Request for Approval to Amend Drawings

Under 37 C.F.R. §1.121

Figure 6

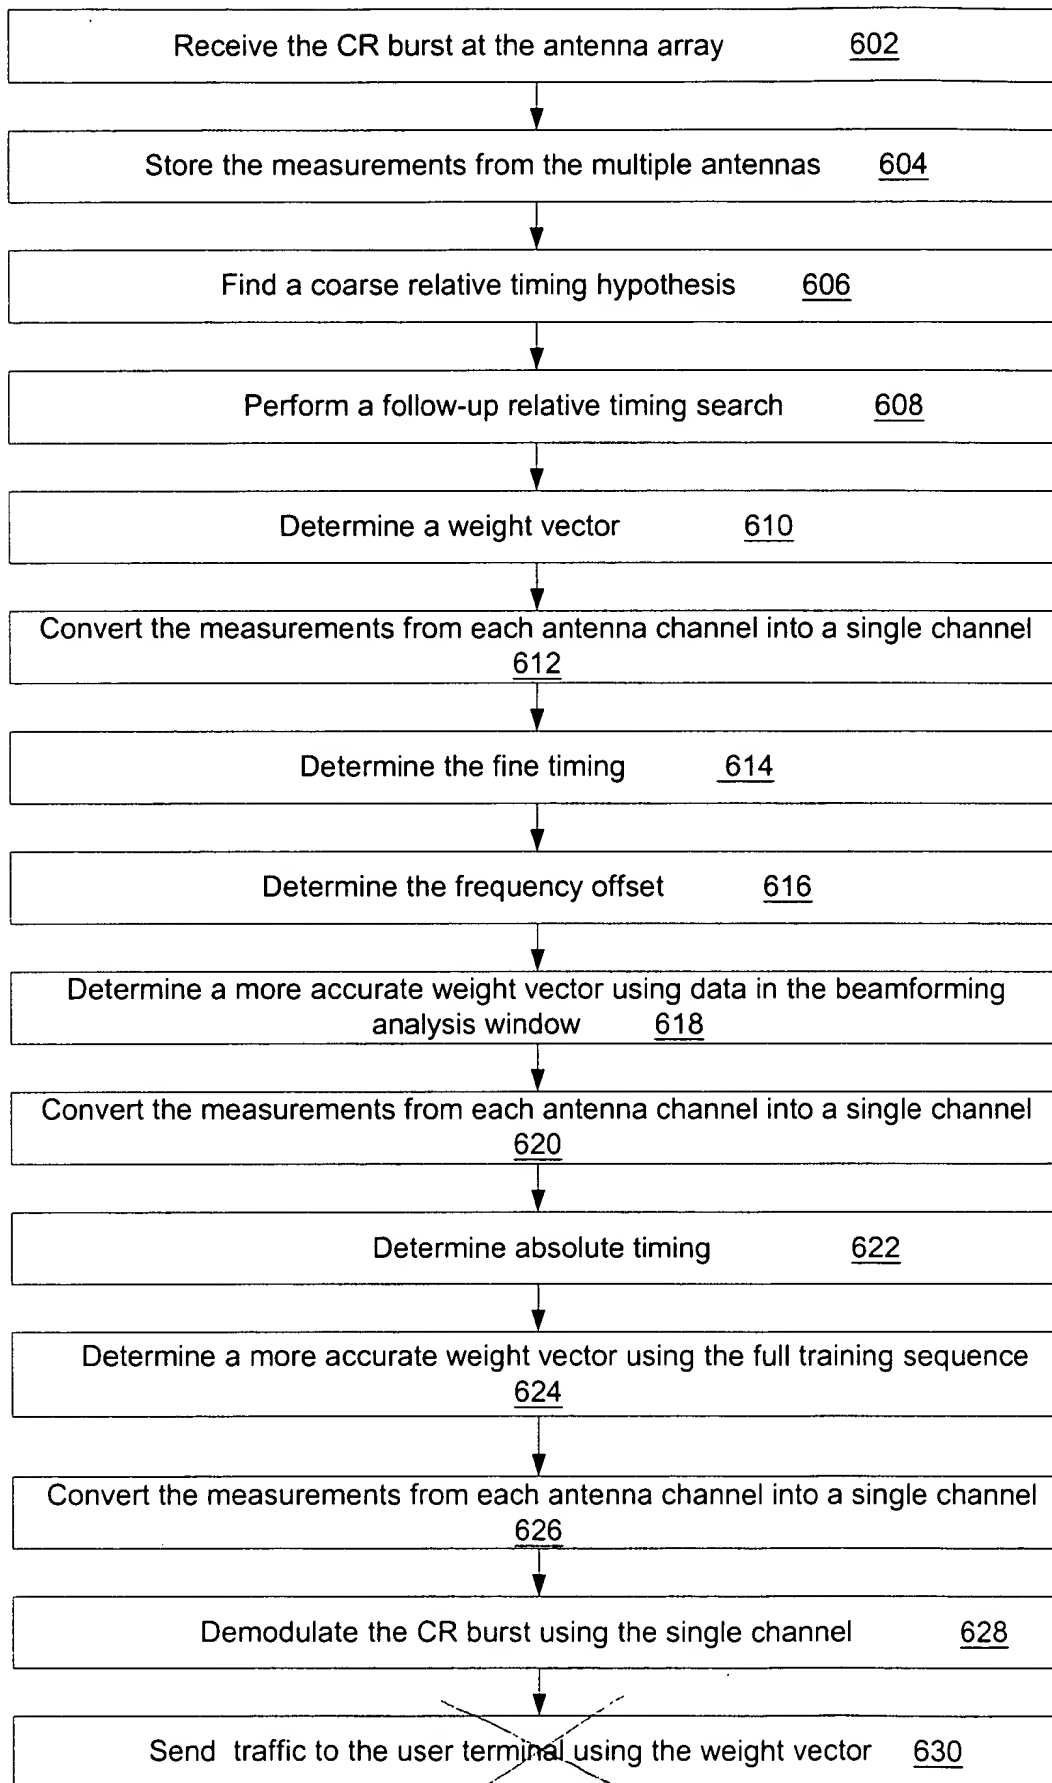
Applicant proposes to delete reference box number 630 in Figure 6.

Accordingly, Applicant has included in a separate letter a red-lined drawing reflecting the proposed changes and a replacement formal drawing. No new matter has been added. The Examiner's approval is respectfully requested for the proposed change to Figure 6.
